**APPLICATION FOR AN IMPROVEMENT PERMIT**

**IMPROVEMENT PERMIT**

Receipt # 4479 LRK# 00027439  
Owner Mark & Wilma Waldron c/o BVH Const.  
Address 119 S Smathers Dr. 7L West Phone No. 315-8537  
Exact Directions to Property: Enter 7LW - T/R Longleaf T/R Smathers  
119 Smathers

System Layout (use applicant's plat or attach to permit) Scale 1 inch = \_\_\_\_\_ feet North

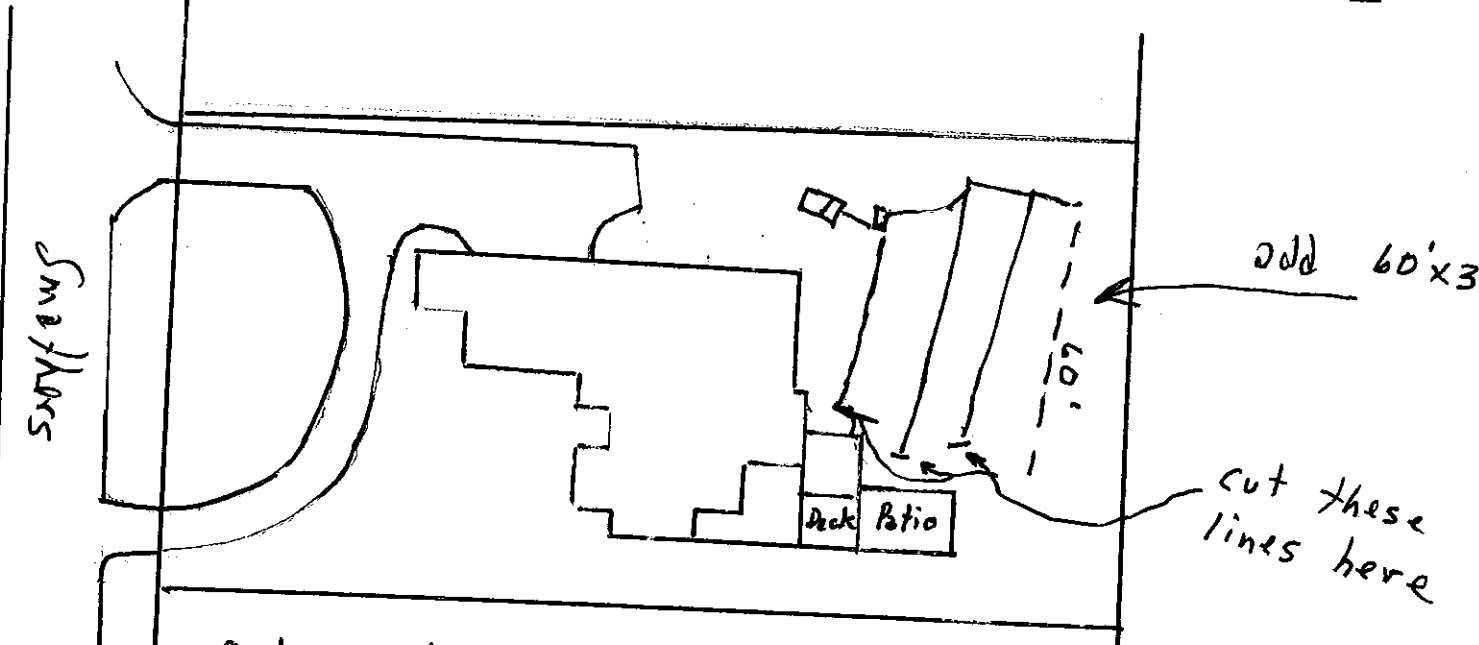
Comments: Cut existing lines - add back line to make up for subtraction to system # Attachments: —
